RE: St. Lucie Units 1 and 2  
Docket No. 50-335 and 50-389  
Request for Additional Information  
Generic Letter 92-08 Response

L-94-275  
St. Lucie Units 1 and 2  
Docket No. 50-335 and 50-389

**FIGURE 1**

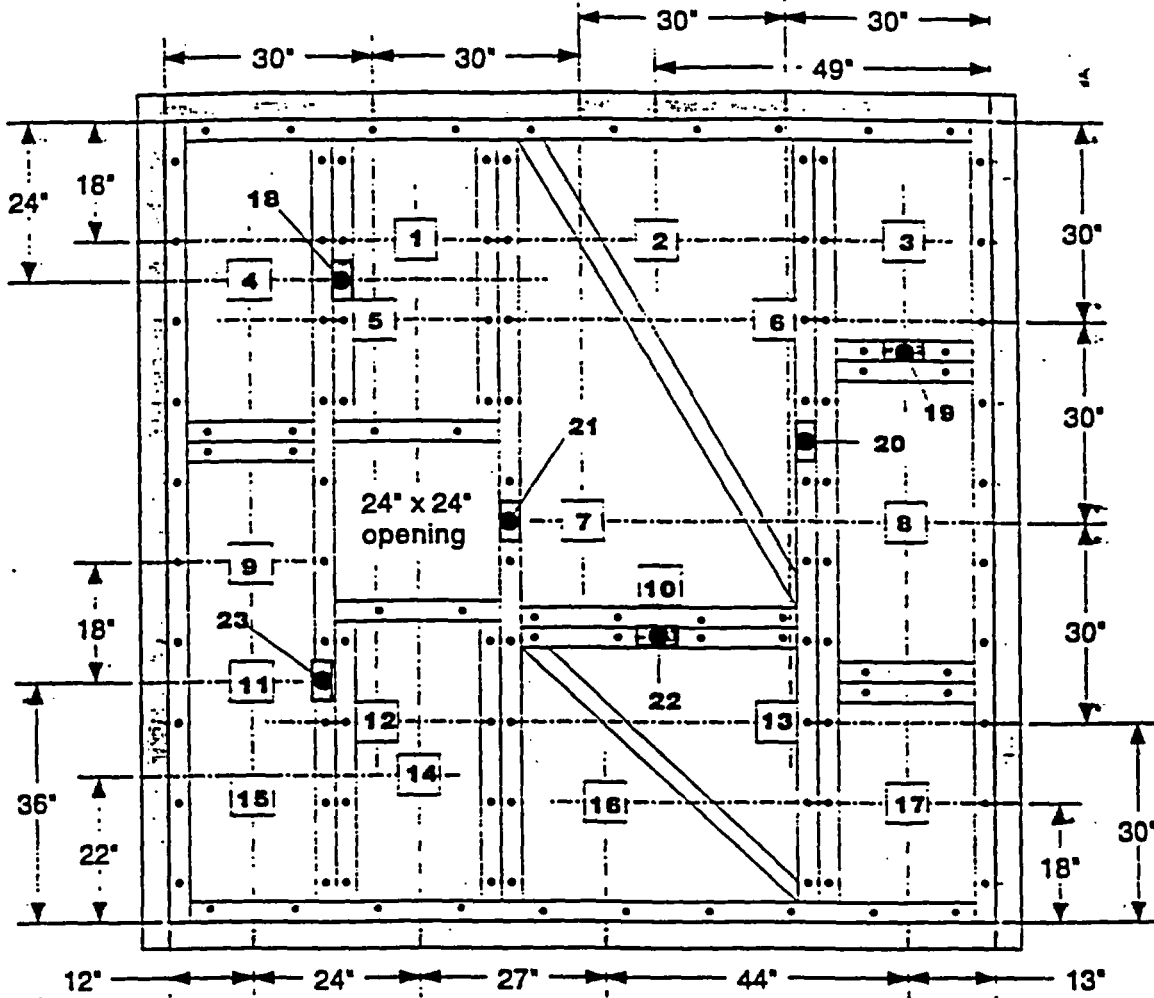
NRC REQUEST (III.B.3.)

If a plant-specific fire endurance test program is anticipated, describe the following:

- a. Anticipated test specimens.
- b. Test methodology and acceptance criteria including cable functionality.

FPL Response (III.B.3.)

The test specimen used was a wall-type configuration of Thermo-Lag material that is representative of the walls, floors, ceilings and radiant heat shields at St. Lucie Plant. The test methodology and acceptance criteria were in accordance with ASTM E-119-88. Cable functionality was not applicable to this test.

The test specimen frame consists of a 10' by 10' assembly designed to hold Thermo-Lag panels. Each panel consists of two one-hour rated boards with a minimum thickness of 1/2 inch, placed back to back with the stress skin out, and bolted to 3"x 3"x 3/8" angles that make up the structural steel framing (see Figure 1). A 1/2" gap was installed along the edge of one panel, and a 1/4" gap was installed along another panel, to emulate a worst case field installation. At the conclusion of the testing a report will be issued and available at FPL engineering offices for review.
